Comment

Comments on “Mathematical Modeling of Current Source Matrix Converter with Venturini and SVM”

Figure 1. The common-emitter (CE) configuration of the IGBT switches [8].

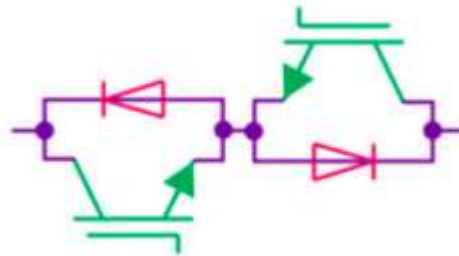
In section 2 of the published article, main topologies for bi-directional switch used in MC are presented in Figure 2. The common-emitter (CE) configuration of the IGBT switches is shown in Figure 2a[1].

The authors want to report that, the presented Figure 2a[1] **is wrong**. It should be for the common-collector (CC) configuration of the IGBT switches.

The suggestive correction for the CE configuration of the IGBT switches is shown in following Figure 1.

Figure 2. The common-collector (CC) configuration of the IGBT switches [8].

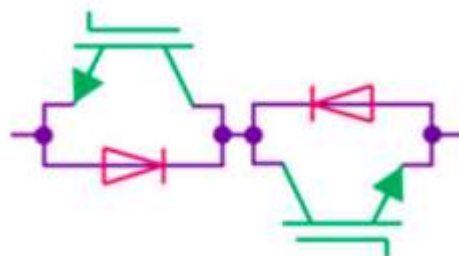
In section 2 of the published article, main topologies for bi-directional switch used in MC are presented in Figure 2. The common-collector (CC) configuration of the IGBT switches is shown in Figure 2b[1].

The authors want to report that, the presented Figure 2b[1] **is wrong**. It should be for the common-emitter (CE) configuration of the IGBT switches.

The suggestive correction for the CC configuration of the IGBT switches is shown in following Figure 2.
